90 Burnett Trail 45 North Fork Bridge Amendment

Motorized Recreation Grant Application

PLAN OF PROPOSED IMPROVEMENT
FOR
Trail 45 Bridge Over North Fork Flowage Replacement
IN THE
Town of West Marshland
Burnett County, Wisconsin

NO.	DATE	REVISION	BY
STRUCTURE TR45 @ N. FK. FLWG			
DRAWN BY ZM		CHECKED ZM	
BRIDGE ELEVATION EXHIBIT			SHEETEX1

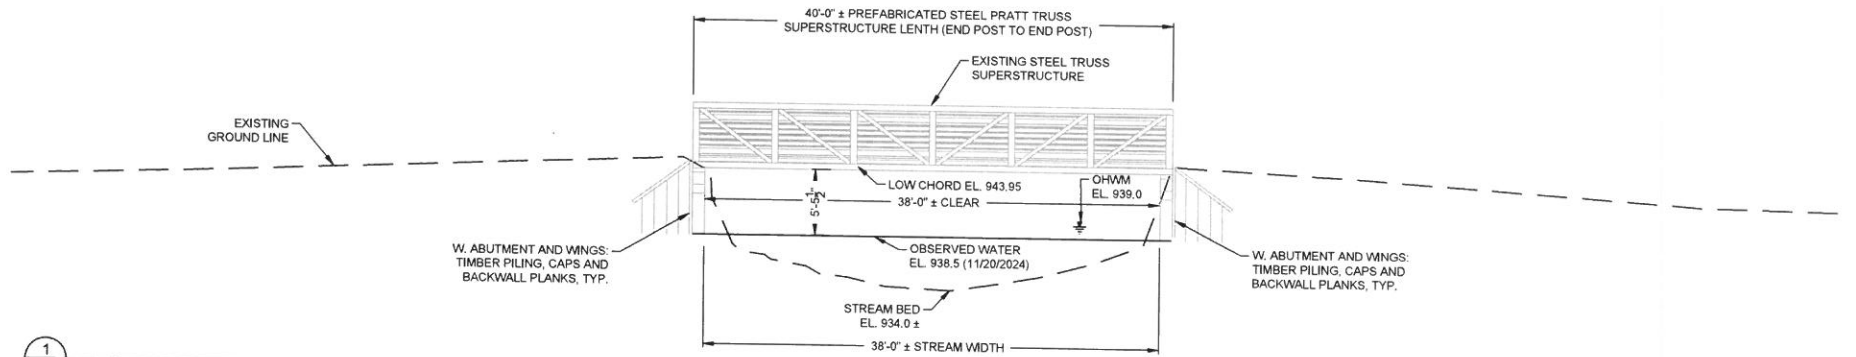
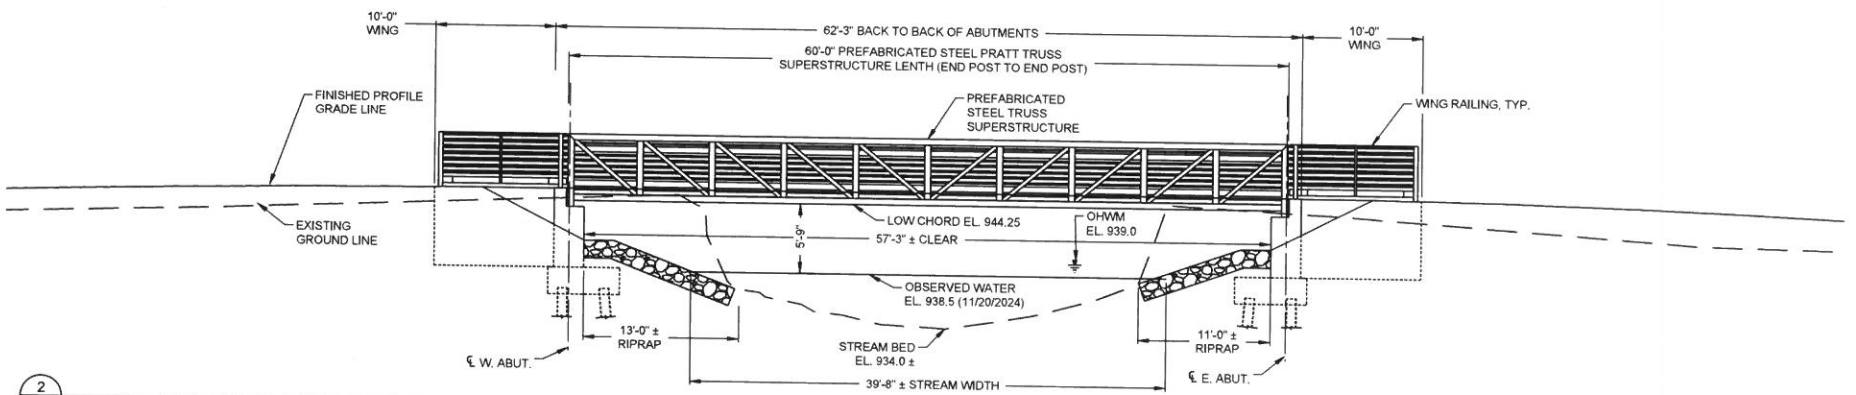
On behalf of Burnett County Forestry and Parks, please see the attached blueprint comparison document prepared by SEH Inc. As you recall, we visited the site on Nov. 12, 2024 to go over conceptual design issues for replacing the bridge over the pumphouse ditch that discharges into North Fork Flowage at Crex.

The multiple plan sheets provided to Burnett Co. were very detailed. I requested SEH to provide a simple addendum that would show the existing structure profile compared to the proposed bridge structure. Obviously the main purpose of my request was to provide you with a side-by-side comparison that would make a relatively easy regulatory decision on whether the proposed bridge would meet the "In-Kind Replacement/Maintenance of a Previously Permitted Structure" exemption. The proposed NR 320 WI Admin. Code includes codification of the "In-Kind" exemption and allows for modification (ie; doesn't need to be exact replication). The current bridge was permitted by Ed Slaminski under a short form application.

We are seeking a determination that the proposed bridge replacement would be exempt from additional Ch. 30 permitting process under the In-Kind Replacement exemption.

Good Morning Everyone; I agree with David's statement that "the proposed bridge would meet the "In-Kind Replacement/Maintenance of a Previously Permitted Structure" exemption. Be sure to send me photos of the completed project.
